Planning comments Reference: 24/0810

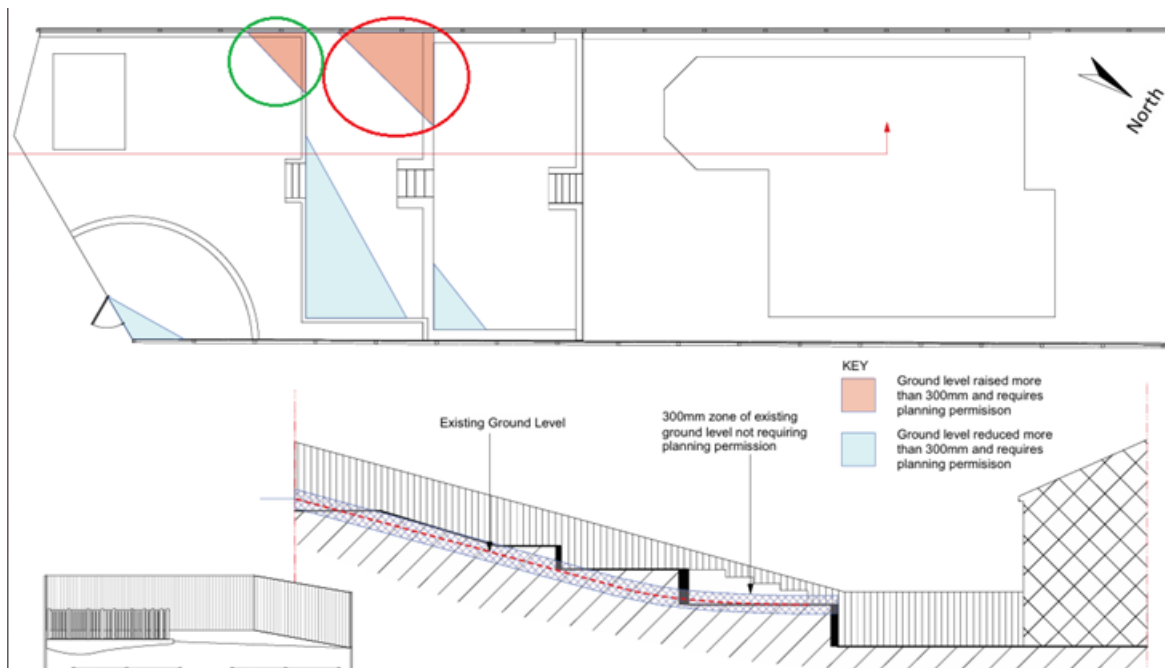
11. The addition of this new amenity space, with attached metal balustrade has created a balcony structure well in excess of 3 metres high, immediately on top of the boundary and facing directly into the immediate rear garden and habitable rooms of number 3. We ask the council to consider this very carefully.

- Again, this is an incorrect and misleading statement. The total height from the ground level to the top of the balustrade measures 2.48 metres – as shown in the photographic evidence below. It is therefore it is totally inaccurate and deceptive to state it “is well in excess of 3 metres high”.
